ADDENDUM NO. 1

FLC Door Hardware and Cylinder Upgrade Project
LRCCD BID NO. 19005

Los Rios – Folsom Lake College - Hardware Bid Walk Questions and Answers

ATHLETIC FIELDS - FLOOR PLAN

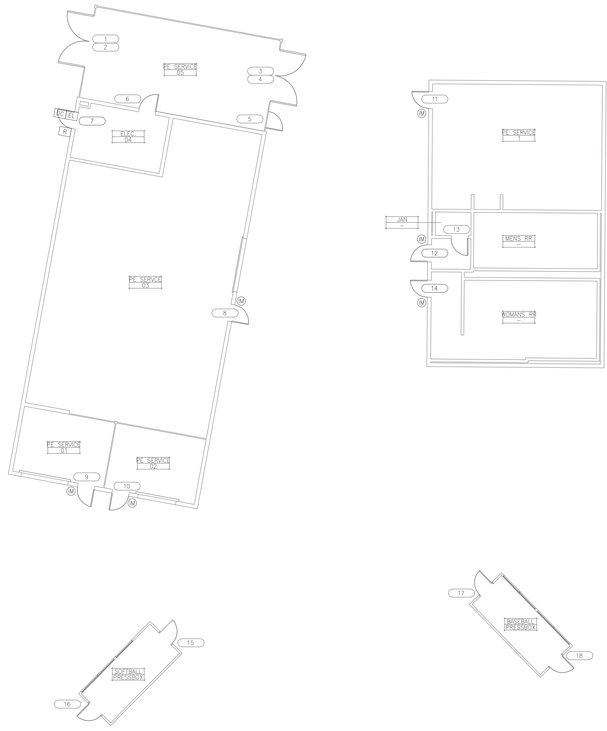
Q1. There are missing new hardware sections on the bid plans, primarily at the Gym and Playing Fields.
A1. The missing information for the New Hardware has been revised.
